Burrah Park – Badgerys Creek

Riparian Assessment – Response to Submissions

Table 6: DCCEE Water Group - RTS Advice

Figure 9: Top of bank and vegetated riparian zones (adapted from ELA 2022)

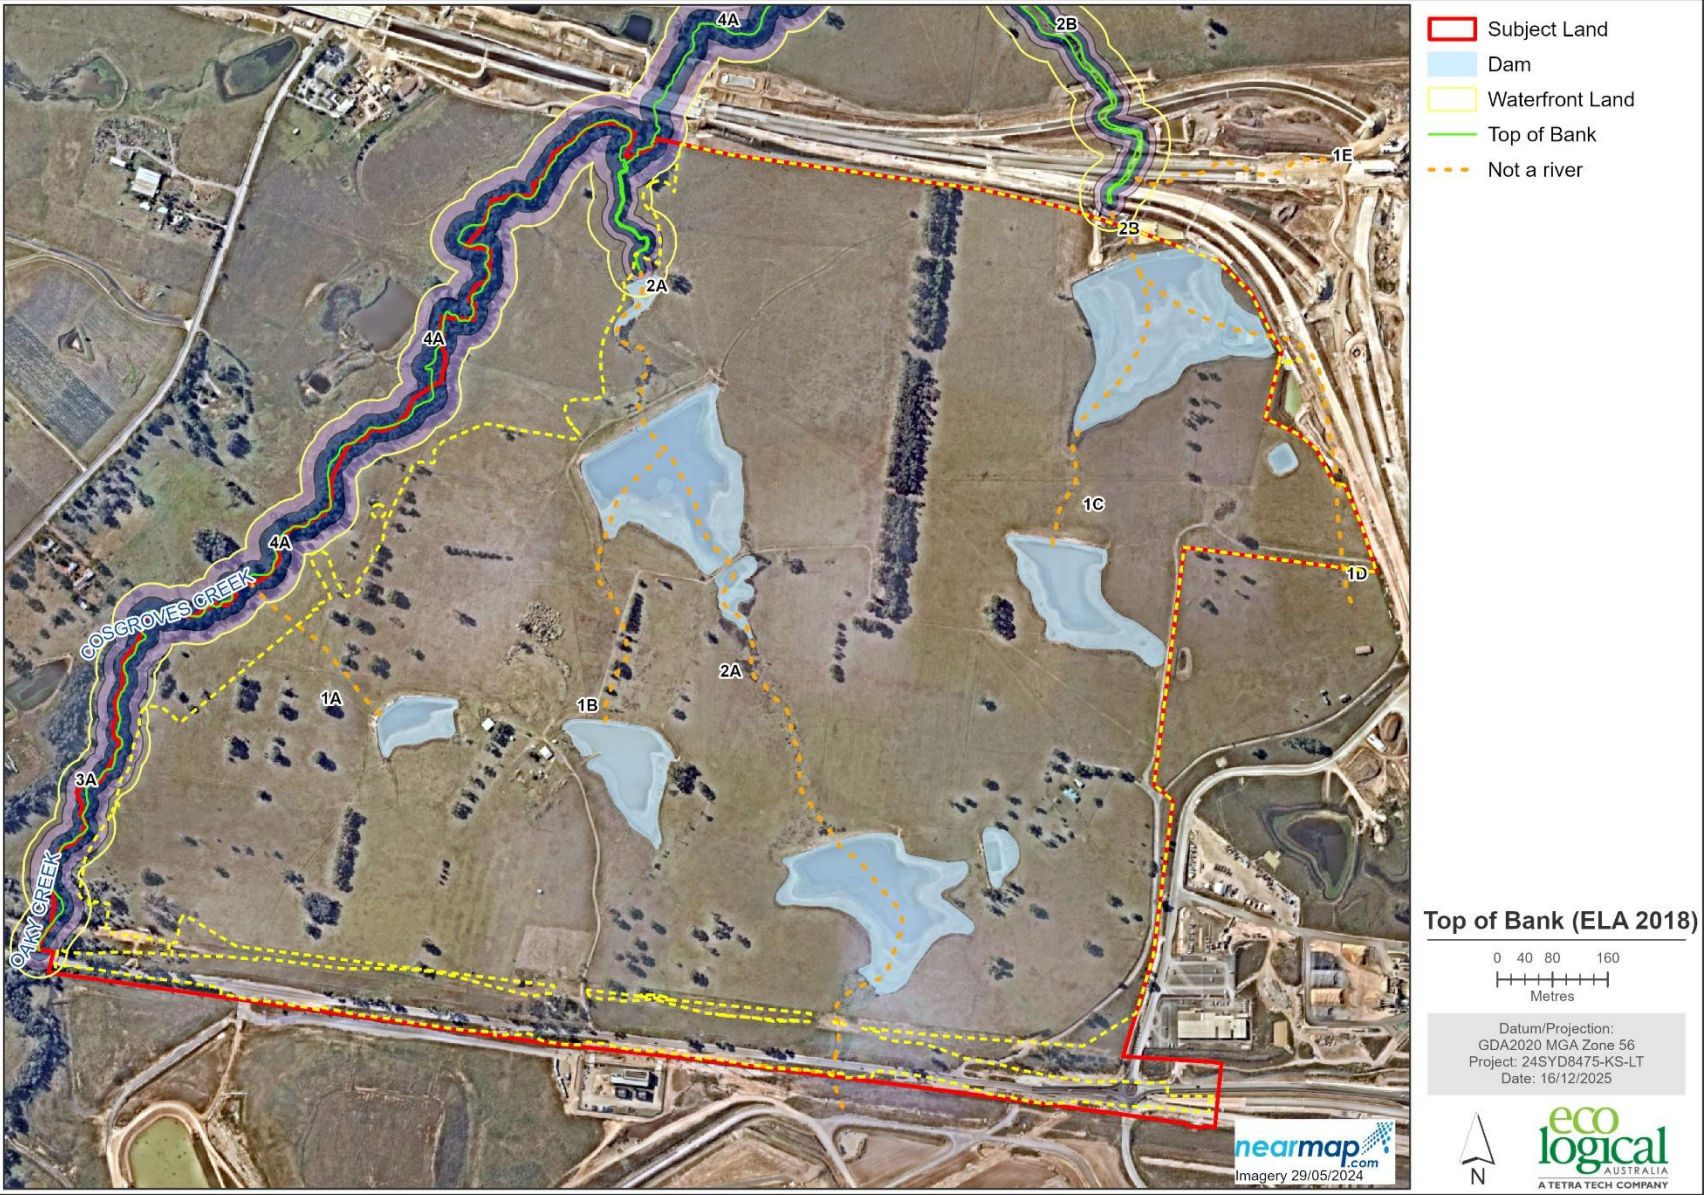
I have reviewed the report title "Riparian Assessment Report Northern Gateway Planning Proposal" Dated August 2018 by ecological Australia". I agree that the evaluation/assessment of the riparian corridor requirements are sound and acceptable in accordance with NRAR guidelines. However, I have concern on the encroachment of the riparian area presented in Figure 9 and must ask why could not be avoided.

Figure 10: Riparian encroachment and offsets

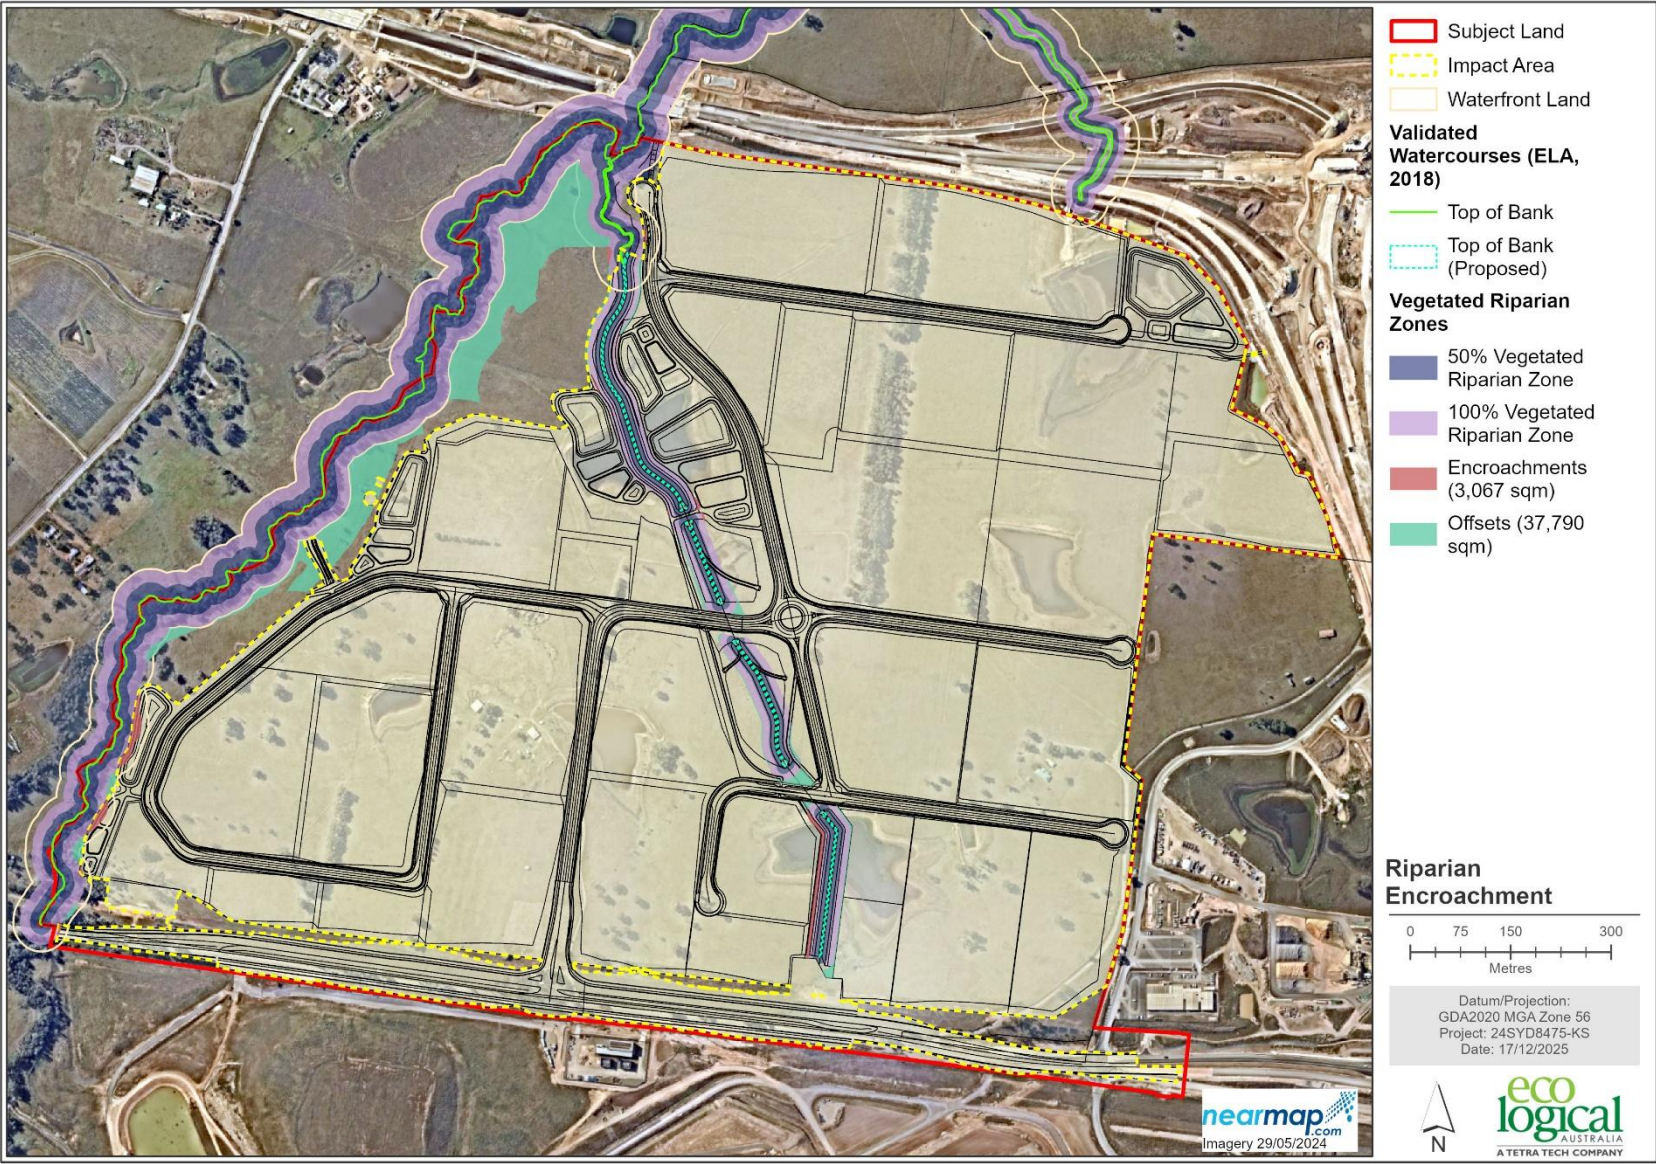
RTS Advice	Response
1.1 Recommendation – pre-determination The Department of Planning, Housing and Infrastructure (DPHI) should seek from the proponent: • A review of the proposed infrastructure footprint and layout to meet watercourse buffer requirements as defined in the Guidelines for Controlled Activities on Waterfront Land. • A plan which clearly identifies the top of bank for on-site watercourses and the associated inner and outer riparian zones and any proposed encroachments or offsets. • Confirmation of the riparian corridor and Vegetation Management Plan planting extent along the second order watercourse in the centre of the site. Explanation: The mapped 2nd order stream within the centre of the site is mapped as an offset area as opposed to a watercourse as the proponent's assessment considers this watercourse did not meet the definition of a river under the <i>Water Management Act 2000</i>. The condition of the watercourse has been significantly modified by agricultural activities but some channelisation is clearly apparent on our imagery despite it being distorted due to current land use. While Water Group can accept the re-alignment on merit, it is still recommended that the riparian corridor width for a second order stream outlined in the guideline is applied. An updated encroachment/offset map is requested to demonstrate the channel and associated riparian area is generally in accordance with the <i>Guidelines for Controlled Activities</i> for the second order watercourse. The VMP provided indicates that the second order watercourse will be fully revegetated. Clarification is required on the width of the planting areas. This information is requested to aid in identifying and confirming riparian corridor widths are consistent with the guidelines. Water Group recommends that the full riparian corridor as prescribed by the guidelines is applied to all 3rd order and higher watercourses with restricted use of the averaging rule. This is important in order to maintain consistency with other developments assessed in the vicinity. Provision of a full corridor has mostly been achieved for Oaky and Cosgrove Creeks which are 3rd order and 4th order watercourses respectively, with the exception of Basin F being within the Oaky Creek riparian zone. It is recommended that this basin is removed from the riparian area and relocated outside of the designated riparian corridor accordingly.	The encroachments and offset map has been updated to demonstrate general consistency with the Guidelines. The Vegetation Management Plan (VMP) applies to an average 20 m wide corridor around the central core trunk drainage alignment, aligned with the offsets map. The proposal provides more offset area than is required by the encroachments into the outer 50% VRZ (Figure 10). Encroachments into Oaky Creek (3rd order) are proposed, in order to facilitate stormwater basins in accordance with Sydney Water requirements. Specifically, Basin F is located in the outer VRZ and therefore encroaching on the riparian corridor. Use of the averaging rule has been applied in this instance, with offsets exceeding 10 times the area of encroachments under the proposal. Offsets will be managed and revegetated under a VMP. While this impact is unavoidable, excess offsets are provided contiguous with Oaky and Cosgroves Creeks.

In relation to works on validated waterfront land, the Project proposes landscaping, a trunk drainage channel, a section of road, road batter, a bioretention basin and wetland (including batter), and drainage outlets (Figure 2, Figure 10). Total encroachment on the riparian corridor (RC) is 3,067 m², which requires offsetting elsewhere along the RC in accordance with the 'averaging rule' outlined in the DCCEEW riparian guidelines (Appendix C). Specifically, a portion of a road within the northwestern corner of the study area encroaches on the vegetated riparian zone (VRZ) of Cosgroves Creek in the outer 50% VRZ only. A proposed bioretention basin and wetland in the southwestern corner of the study area (Basin F) constitutes another encroachment, though minor (0.15 ha), on the outer VRZ. Offline detention basins do not need to be offset if an equivalent vegetated riparian zone (VRZ) for the corresponding watercourse is included. However, as the proposed basin does not have a VRZ, it will be offset elsewhere along the riparian corridor. The proposal is consistent with the Guidelines, as it does not encroach on the inner 50% VRZ and an equivalent or greater area is proposed to be offset.

No development is proposed within the inner 50% VRZ (Figure 10). Potential offset areas, which are also associated with a VMP, are available in the study area at more than 10 times the encroachment area. A total of 37,790 m² of offsetting through revegetation is proposed.

The proposal has been amended to achieve improved consistency with the Guidelines, avoiding realignment the validated extent of reach 2A and proposing a naturalised trunk drainage path for the remainder of reach 2A. This includes average 20 m wide corridor, to be managed under a Vegetation Management Plan (VMP) and improving the condition from its current state as an overland flow path. Road crossings are proposed on the trunk drainage channel at several points, consistent with the Guidelines. Areas of encroachment and offsets have also been considered within the central trunk drainage channel, and are aligned with the Guidelines for 2nd Order watercourses (Figure 10).
